October 23, 1997

Re: Installation of Spring Drain to obtain Construction & Demolition Debris Landfill Permit
Buncombe County Solid Waste Management Facility

RE: Hydrogeologic Technical Review of the Design Hydrogeologic Report - Proposed Construction and Demolition Debris Landfill: Buncombe Co.

DETAIL D

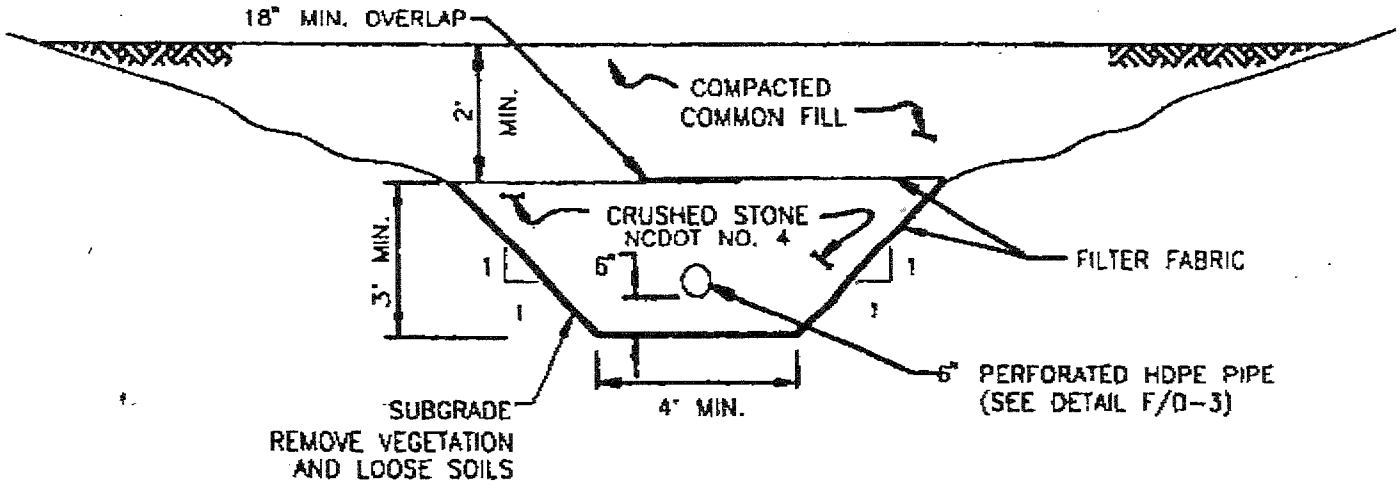
In order to satisfy comments in the Solid Waste Section's technical review memorandum dated October 10, 1997 concerning the location of groundwater discharge and springs, we are submitting the following items:

Page 14-25: The groundwater discharge location identified in the C&D Landfill area is not shown on any of the sheets submitted. Submit a revised sheet showing the discharge location. Two springs were observed in the foot print of the C&D Landfill cell during a recent site visit by the Solid Waste Section staff. If both springs in the C&D Landfill foot print are different than the one previously observed, they also need to be included on a revised sheet.

1) Detail of the Spring Drain
